SUBJECT LAND: 141-147 Queens Parade, Clifton Hill

Attachment 2 - PLN170718 - 141 - 147 Queens Parade, Clifton Hill - Advertising S57B - Plans

City of Yarra Heritage Advice

MEMO

Above: Extent of original roof structure to be retained shown shaded in blue

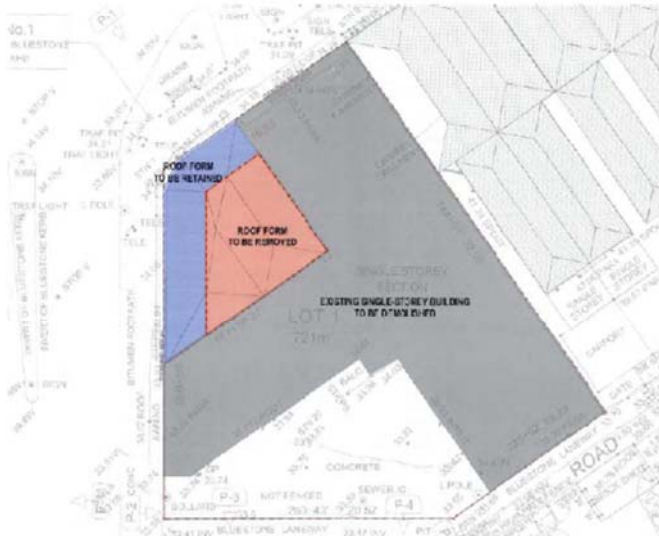
The extent of demolition proposed by this application includes the demolition/removal of the rear part of the original building at ground and first floor levels and a majority of the associated roof structure behind the front pitch. Demolition includes removal of all the later additions.

The demolition of the entire flat roofed built form at the rear of the original building and the addition to the side (no. 147) is supported on the basis that these are later additions that do not contribute to the cultural significance of the place.

The removal of part of the original floor area at the rear of the ground and first floor levels will not be visible from either of the street frontages. The removal of these areas will not negatively affect the significance of the place.

Above: Extent of original roof form that should be retained shown shaded in red

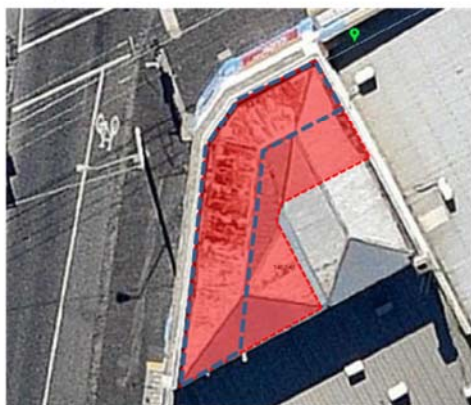
In regard to the roof structure, it is proposed to remove more than half of the original roof structure (refer to blue line on the diagram below). This means that the roof form of the main building will not be maintained, contrary to the policies set out in Clause 22.02-5.1. It is acknowledged that the existing roof form is not generally visible except from distant views. The extent of roof structure to be retained will be to a depth of about 3 metres from the street facades. At this depth the existing ridgeline will be maintained. Although it would be preferable that the extent of roof shown shaded red in the diagram below be retained, it is recognised that the removal of the roof structure to the 'inside' of the existing roof will not be perceivable from any vantage point at street level.

Therefore on this basis, **the extent of roof demolition proposed in this application is considered acceptable.**

Ground Clearance for a B99 at a Sag Transition Grade

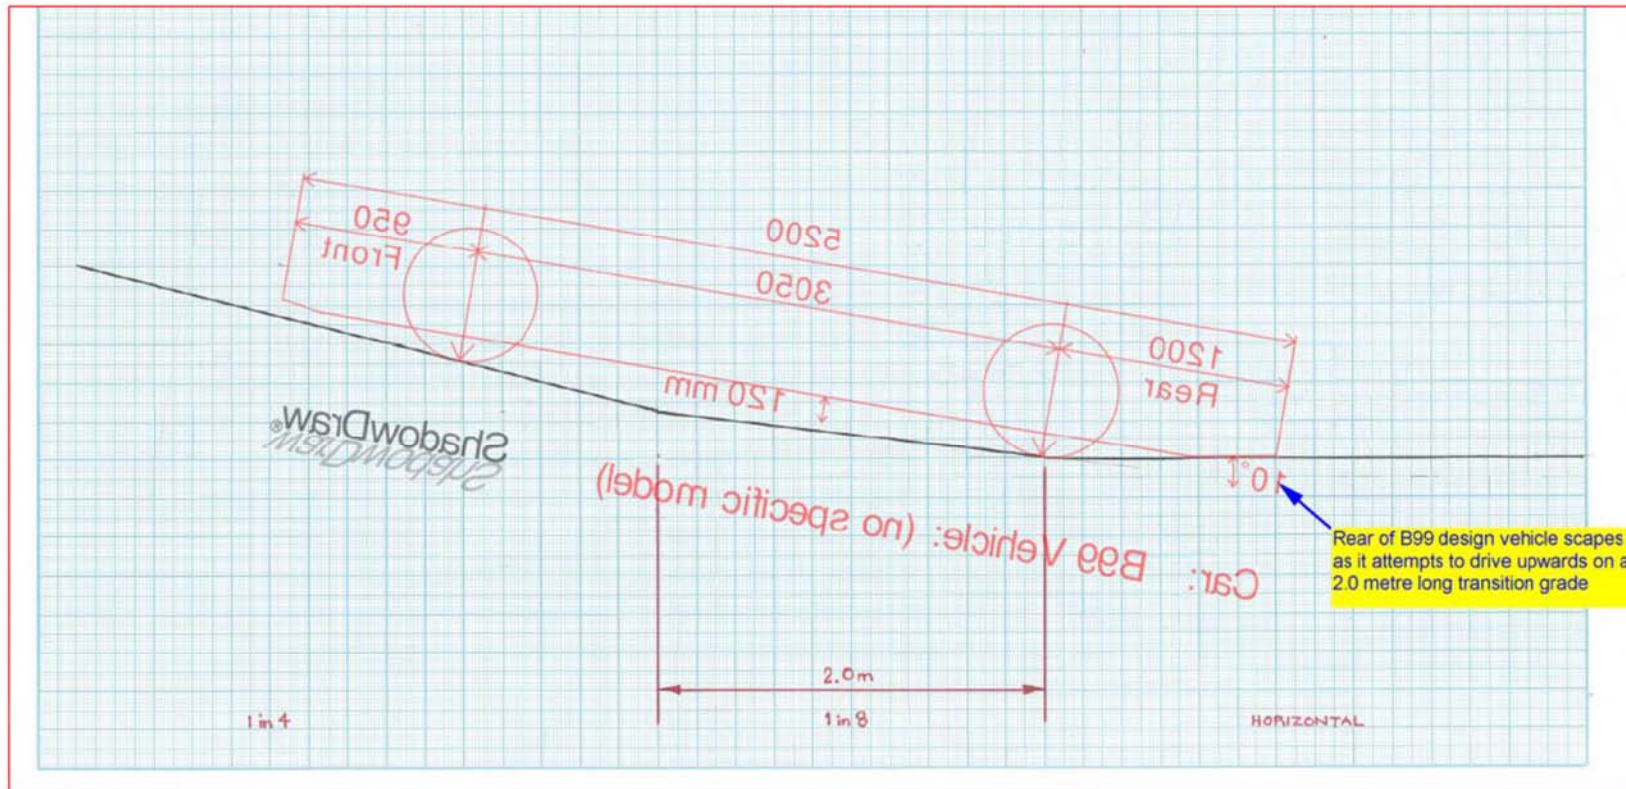
Transition Grade at Base of 1 in 4 Grade Section	The length of the 1 in 8 transition grade at the base of the 1 in 4 ramp section needs to be increased to 2.5 metres in order to satisfactorily accommodate the ground clearance of a B99 design vehicle.

Bottoming out/scaping of a B99 design vehicle when traversing 2.0 metre long transition grade at the base of a 1 in 4 ramp grade section
